Addendum No. 4

Date: April 15, 2013
To: Contractors
From: Matthias Mueller – Program Director
Reference: Bachelor Enlisted Quarters Facility
Utah National Guard – Camp Williams, Utah
DFCM Project No. 10281480

ADDENDUM FOUR

BACHELORS ENLISTED QUARTERS FACILITY

DRAWN BY	WRT	CHECKED BY	DLA
PROJECT NO.	11007	DRAWING NO.	EL101B
DATE	02/15/2013

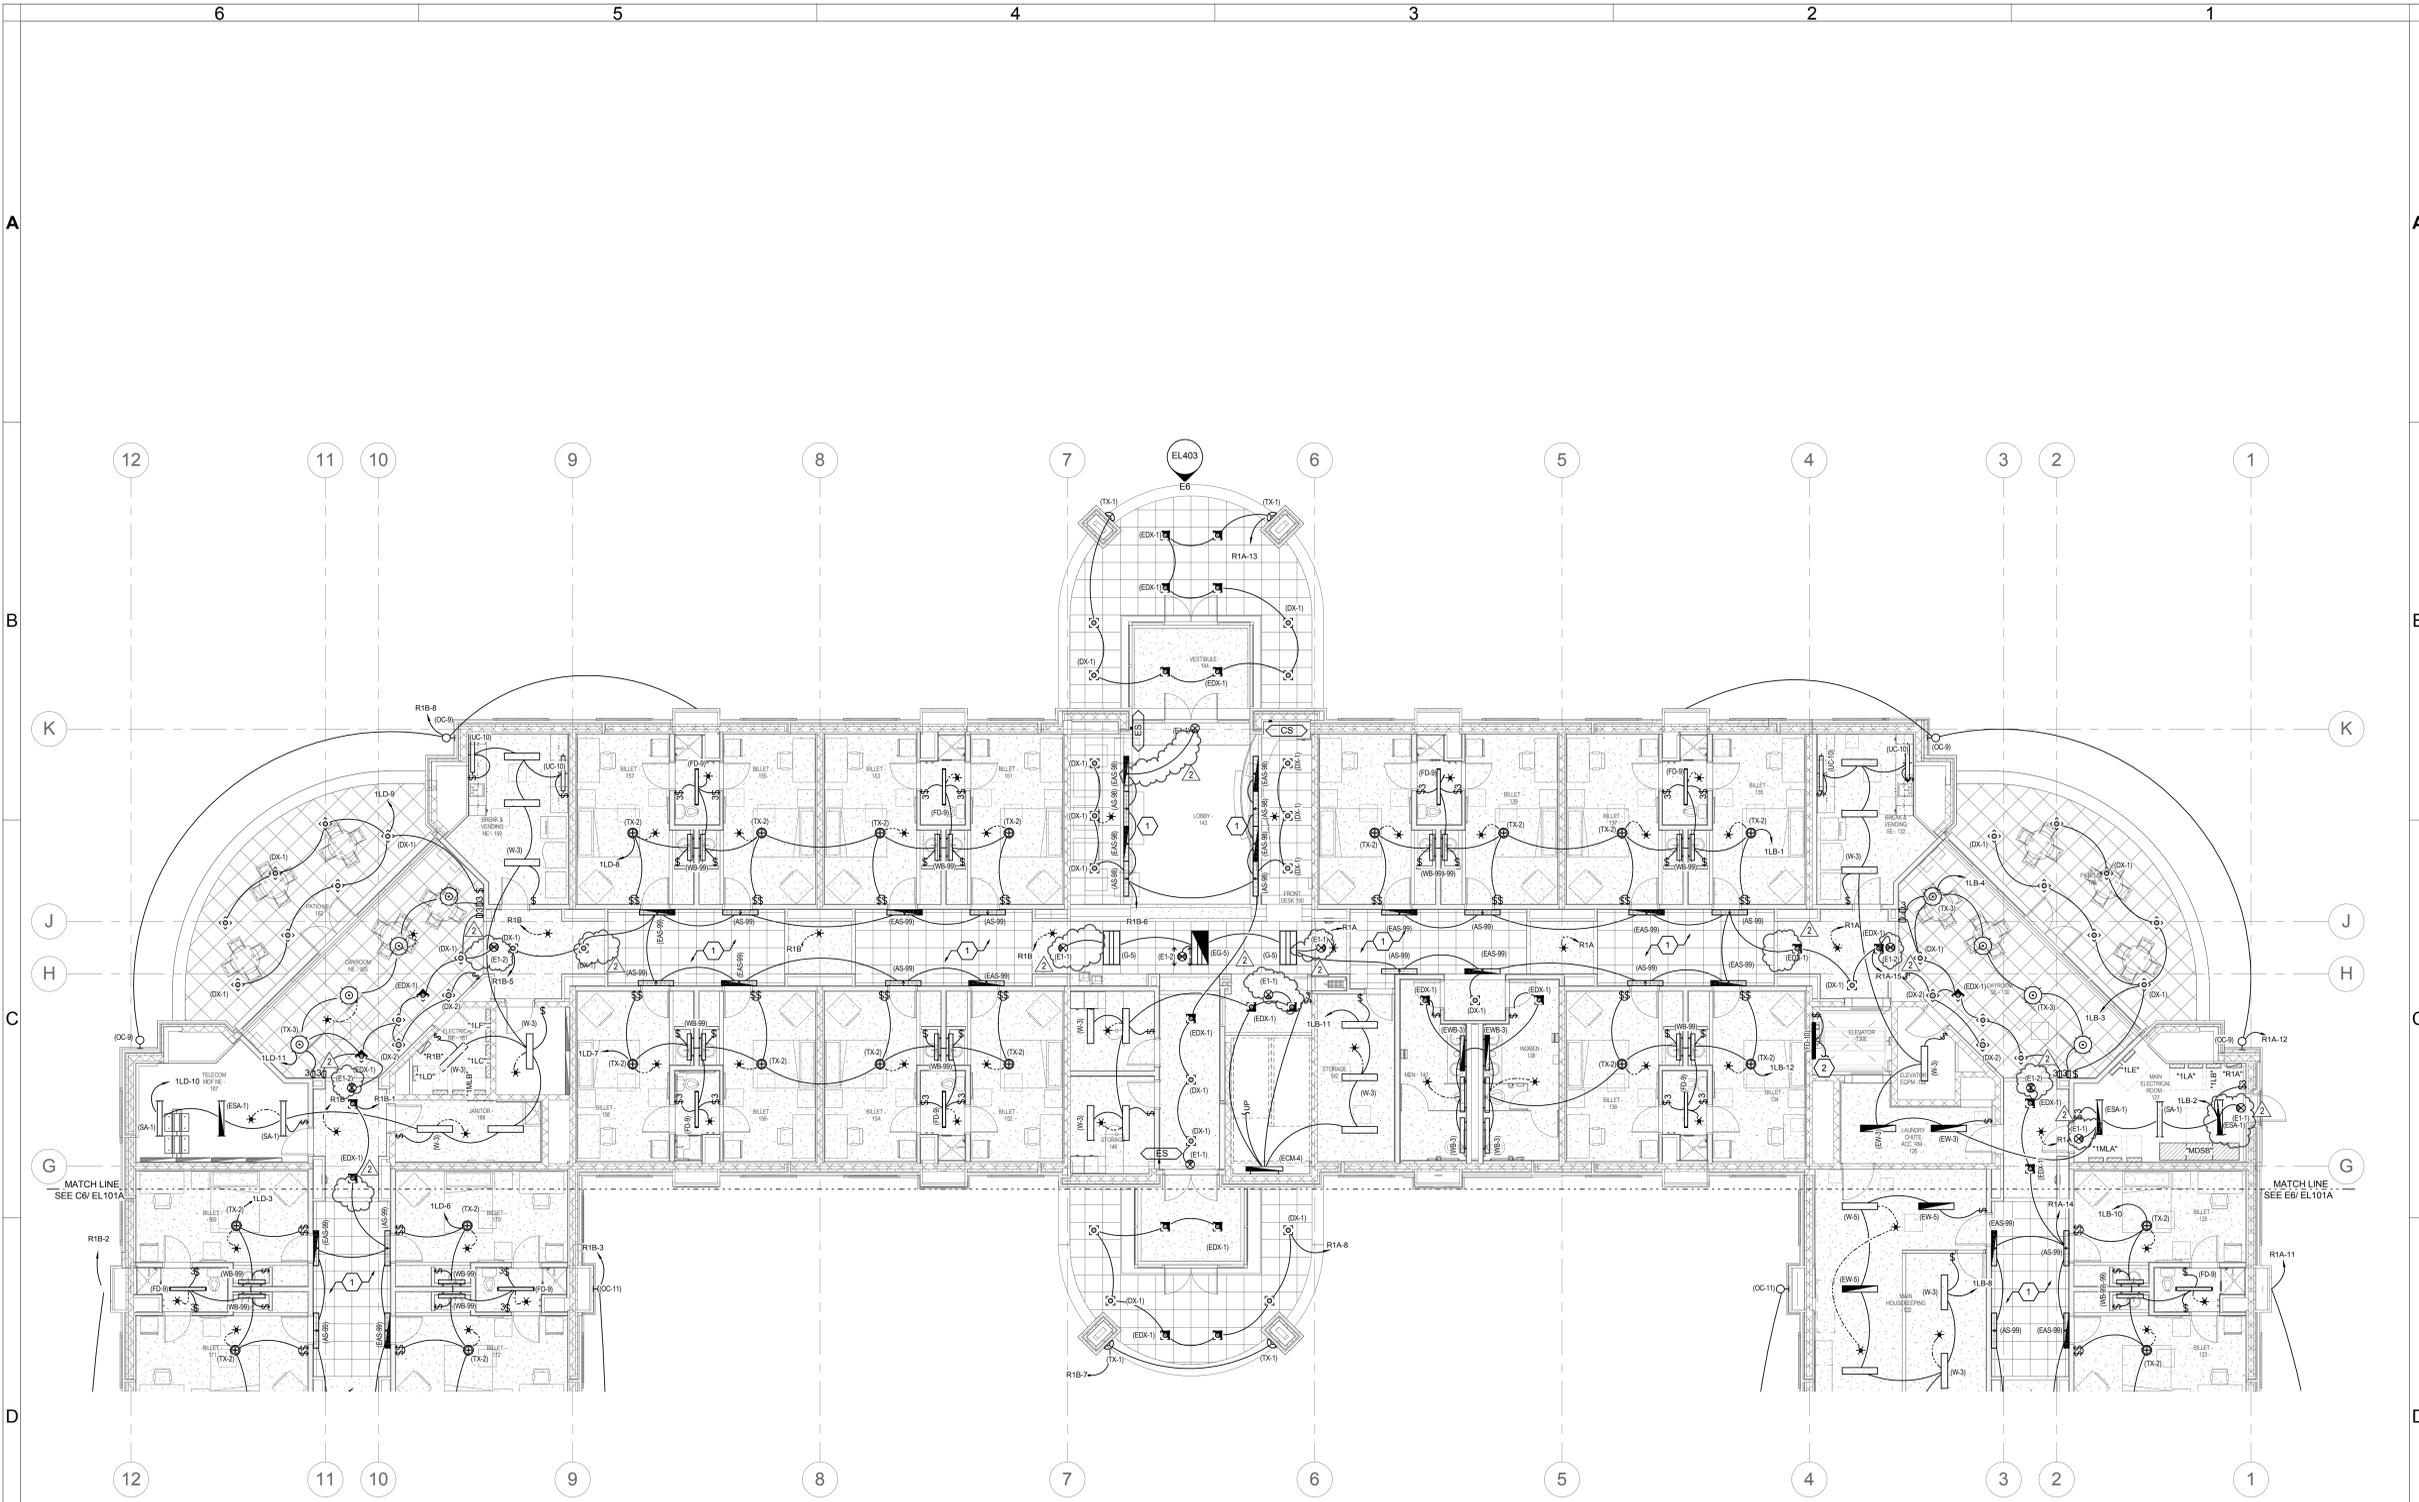
- a. Added (2) 2-sided exit signs near Dayroom NE-165. Deleted (2) single sided exit signs in the corridors near the same dayroom.
- b. Added (1) exit sign in the stairwell across from Front Desk 150.
- c. Added (2) 2-sided exit signs near Dayroom SE-130. Deleted (1) single sided exit sign in the corridor near the same dayroom.
- d. Added power connection to the exit sign in Lobby 143.
- e. Added (2) exit signs on the lower ceilings of the corridors entering the lobby area for improved visibility.
- f. Add (2) exit signs in Main Electrical Room-127.
- g. Change one of the SA-1 fixtures to an ESA-1 fixture with a battery pack.

DRAWN BY: **WRT** CHECKED BY: **DLA**
 PROJECT NO: **11007** DRAWING NO: **EL102A**
 DATE: **02/15/2013**

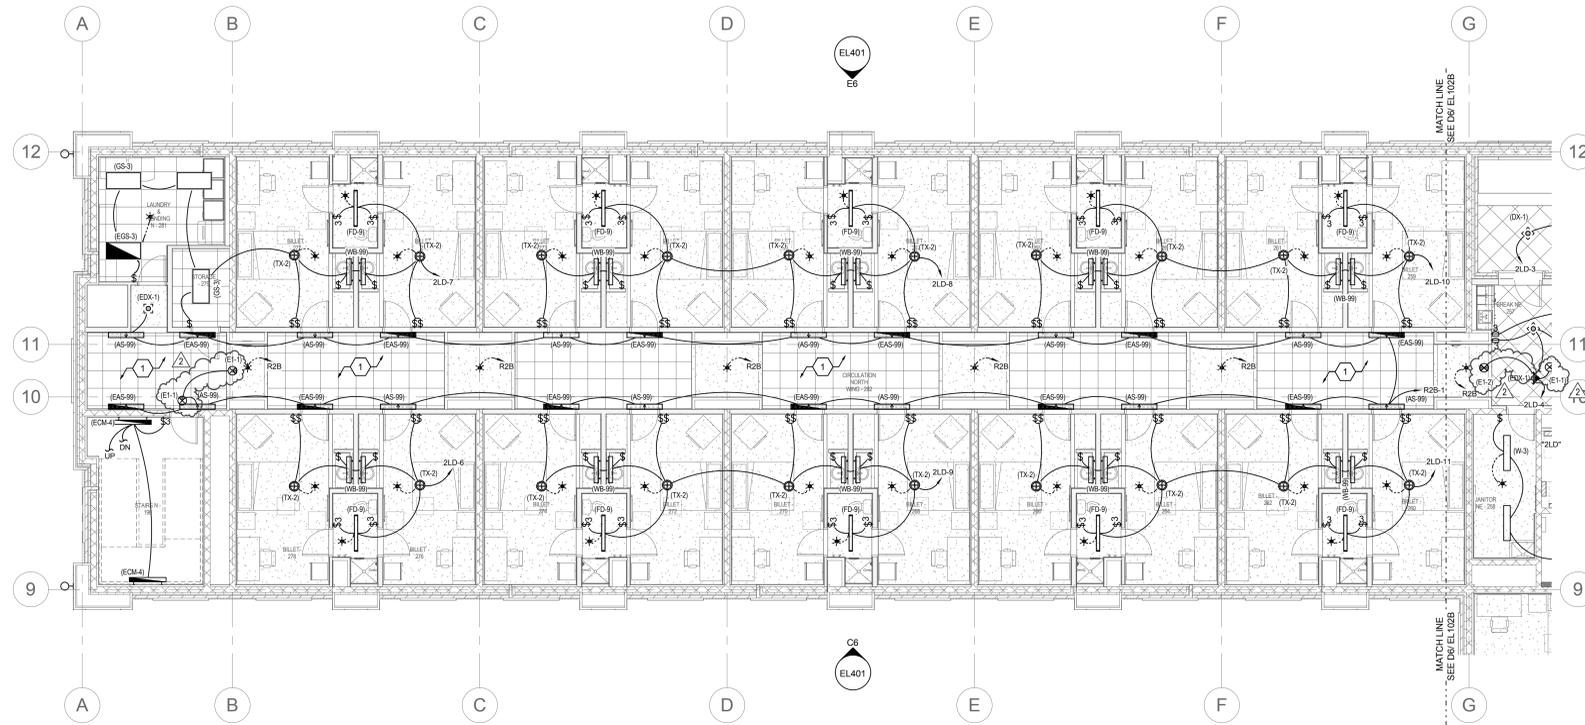
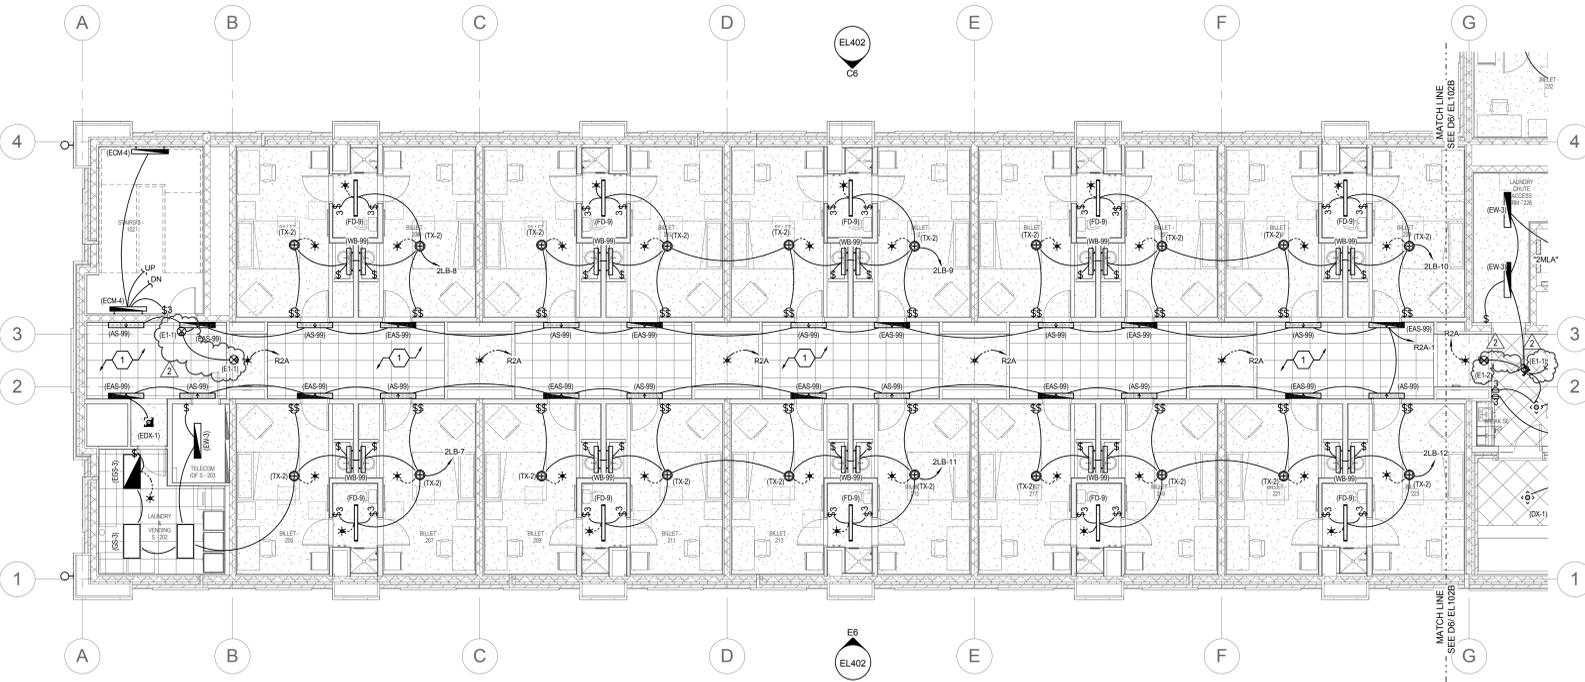
- a. Added (1) exit sign directly above the door to the stairwell on the west end of the north wing. Relocated the existing exit sign to the east to the lower ceiling for visibility. Added circuiting to the exit signs at that stair.
- b. Added (1) exit sign directly above the door to the stairwell on the west end of the south wing. Relocated the existing exit sign to the east to the lower ceiling for visibility. Added circuiting to the exit signs at that stair.

DRAWN BY: **WRT** CHECKED BY: **DLA**
 PROJECT NO: **11007** DRAWING NO: **EL103A**
 DATE: **02/15/2013**

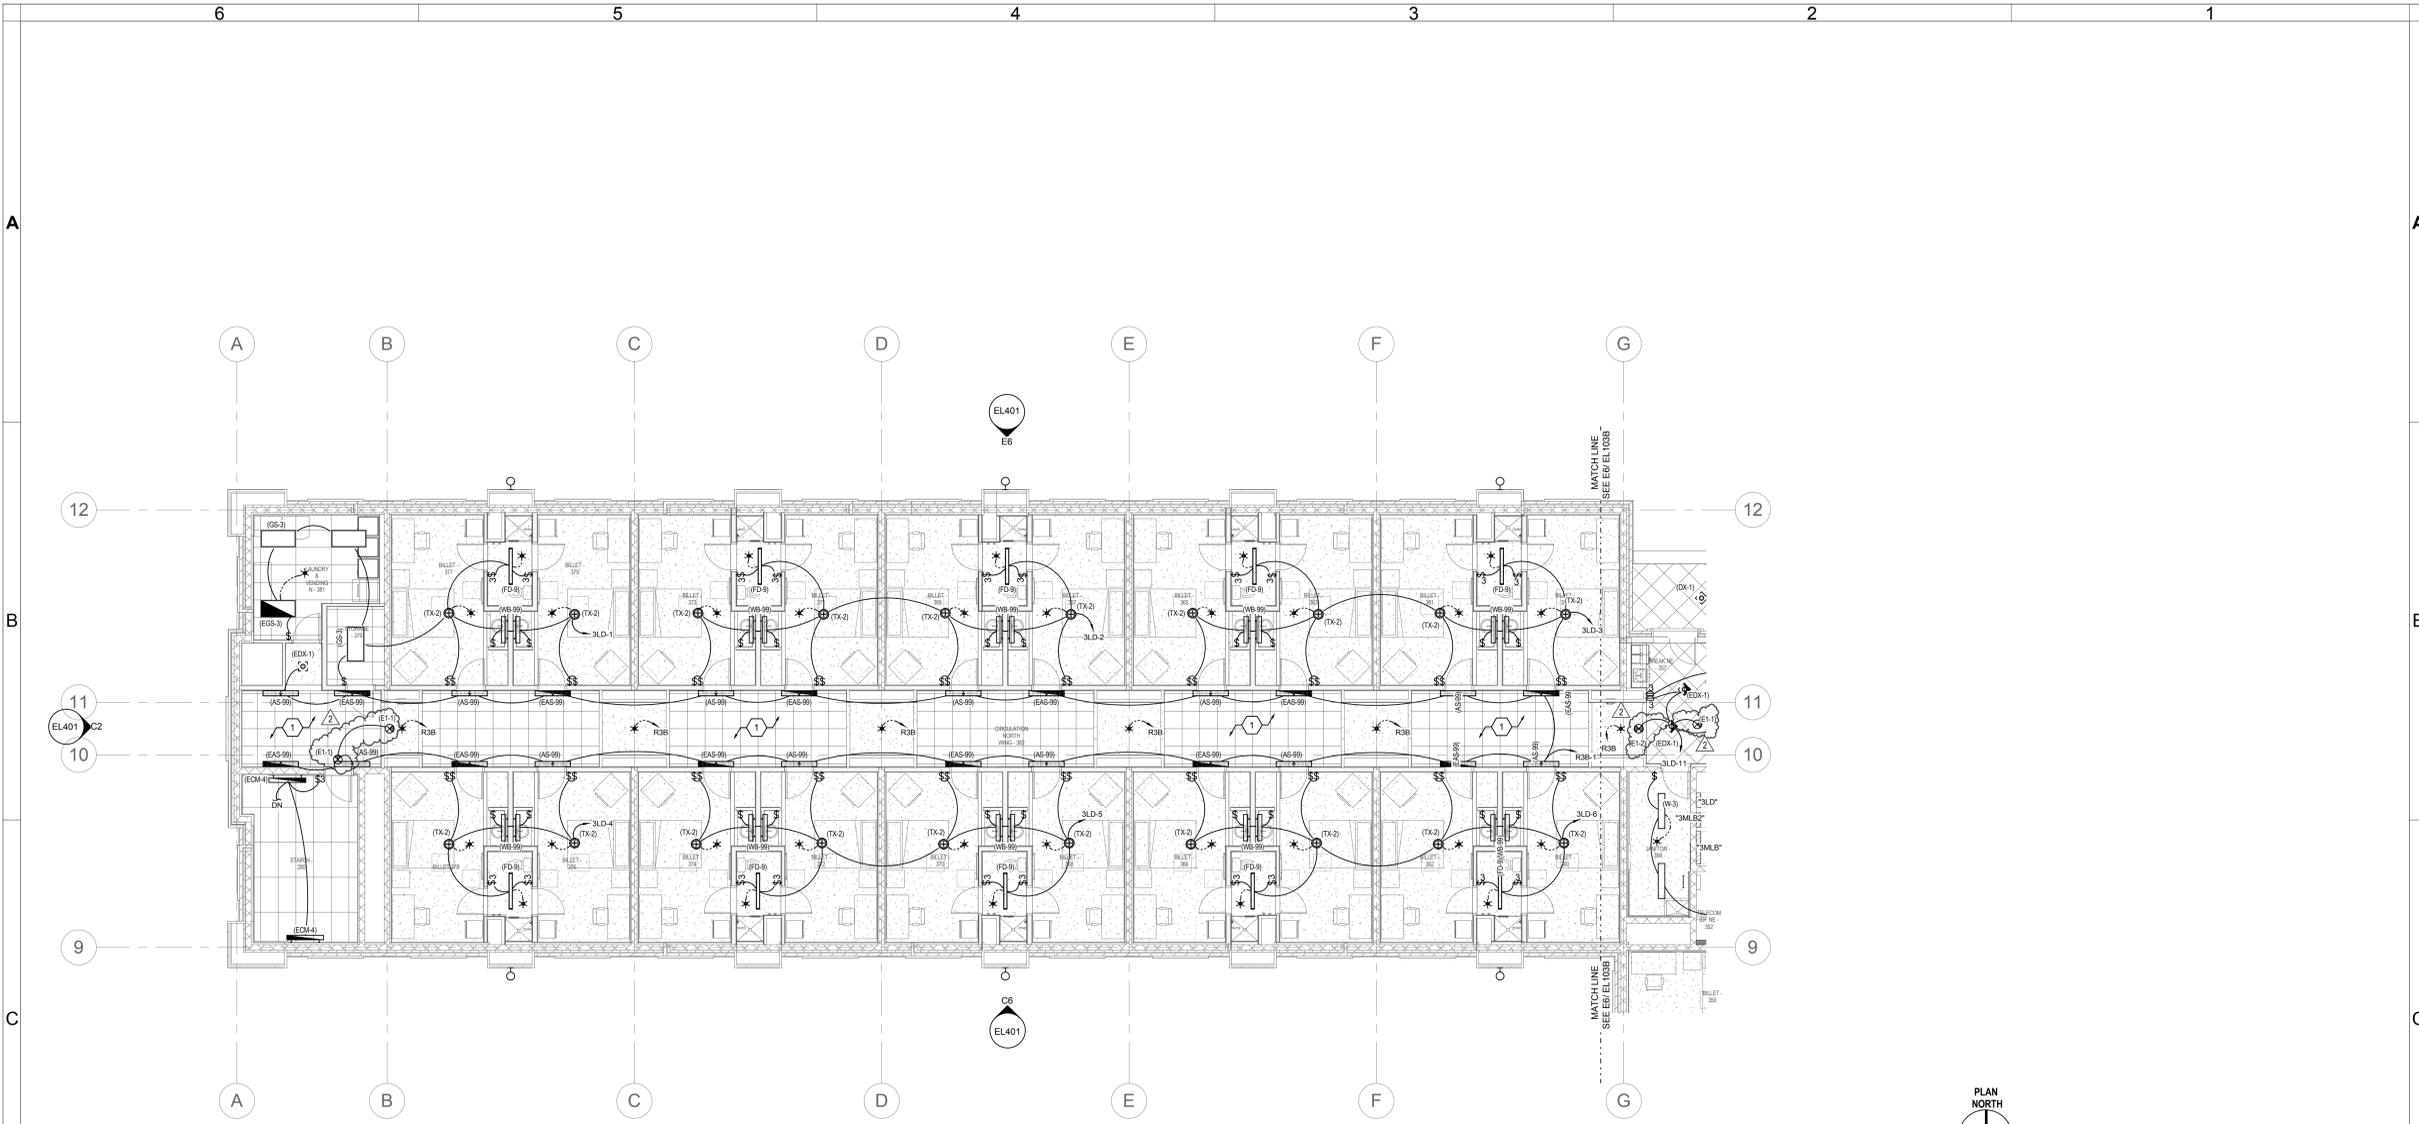
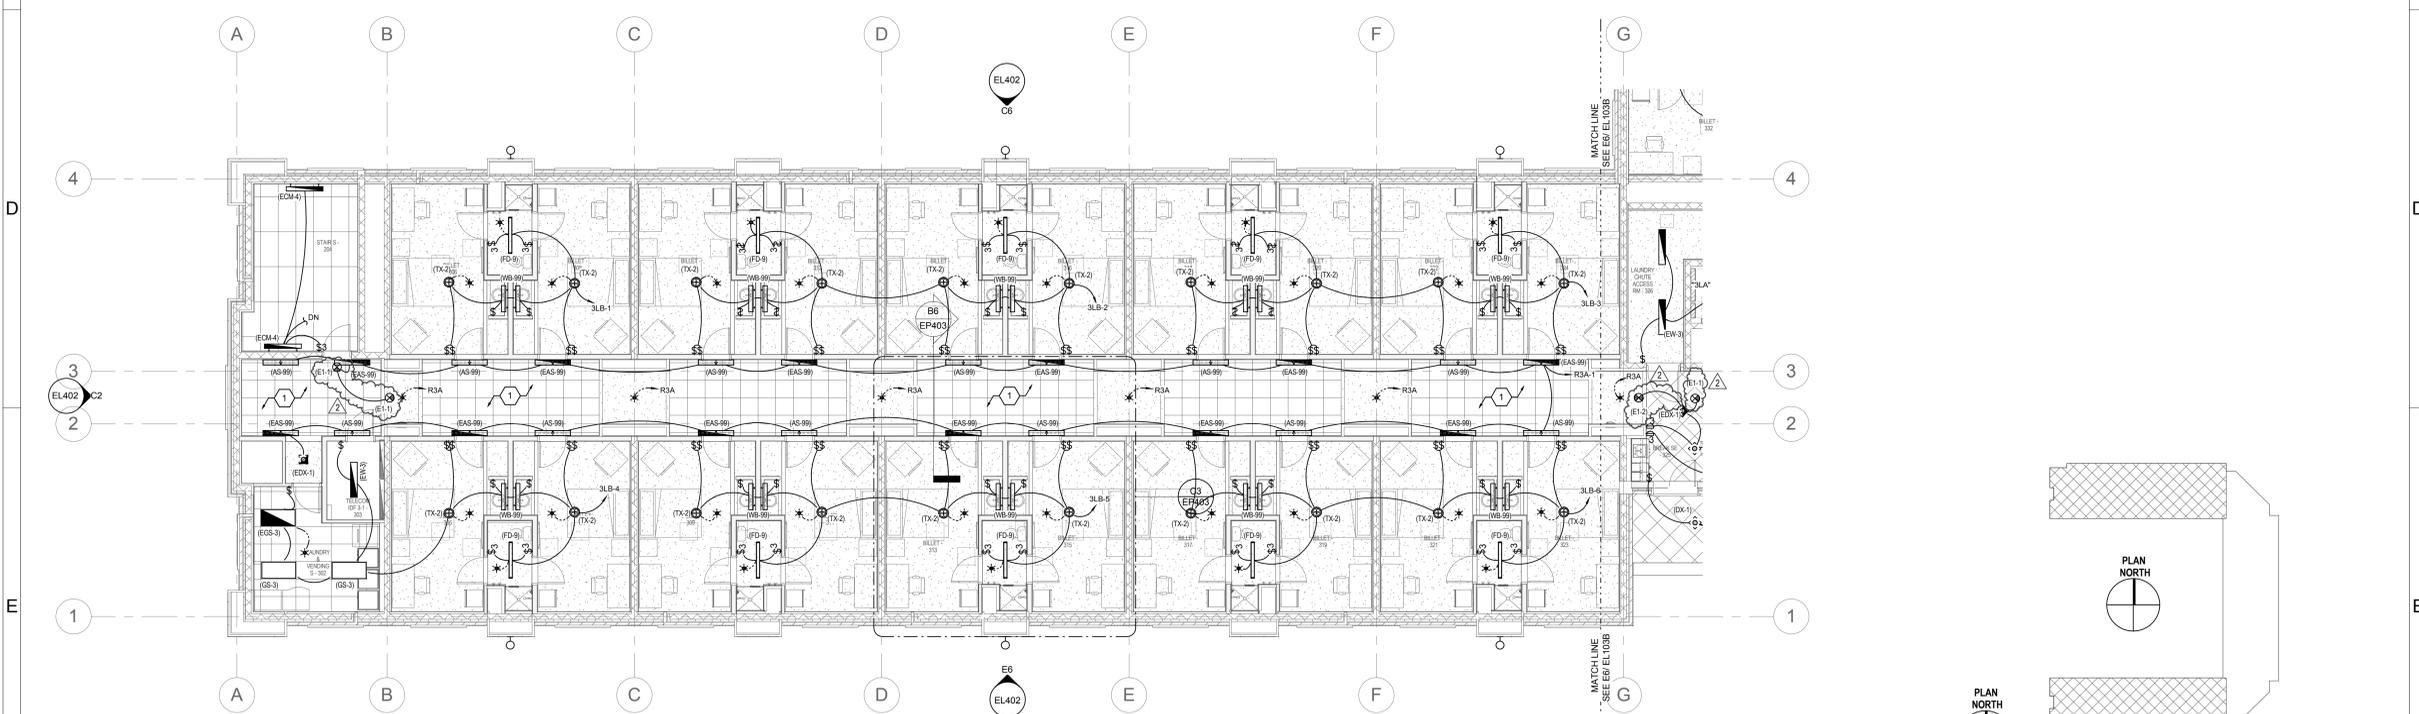
- a. Added (1) exit sign directly above the door to the stairwell on the west end of the north wing. Relocated the existing exit sign to the east to the lower ceiling for visibility. Added circuiting to the exit signs at that stair.

- b. Added (1) exit sign directly above the door to the stairwell on the west end of the south wing. Relocated the existing exit sign to the east to the lower ceiling for visibility. Added circuiting to the exit signs at that stair.
